**ORIGINATING MARKER CONNECTOR FRAME
EQUIPMENT DESIGN REQUIREMENTS
NO. 1 CROSSBAR SYSTEM**

1.001 This addendum supplements Section 816-302-150, Issue 6.

1.002 This addendum is issued:

Fig. 1—Originating Marker Connector Frame

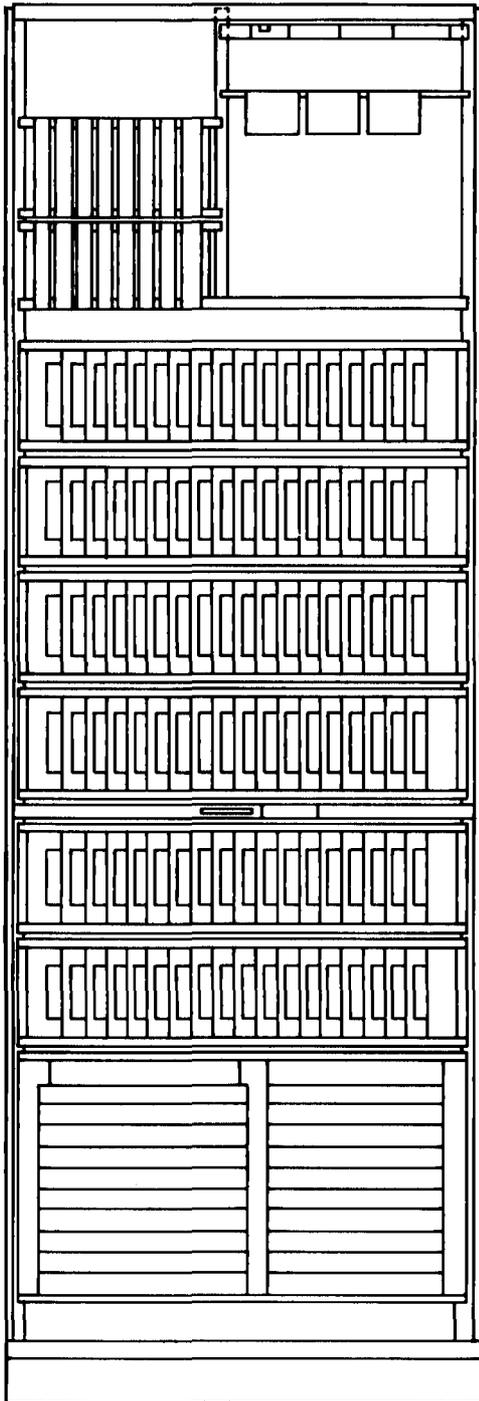
- (a) Figure 1 revised.
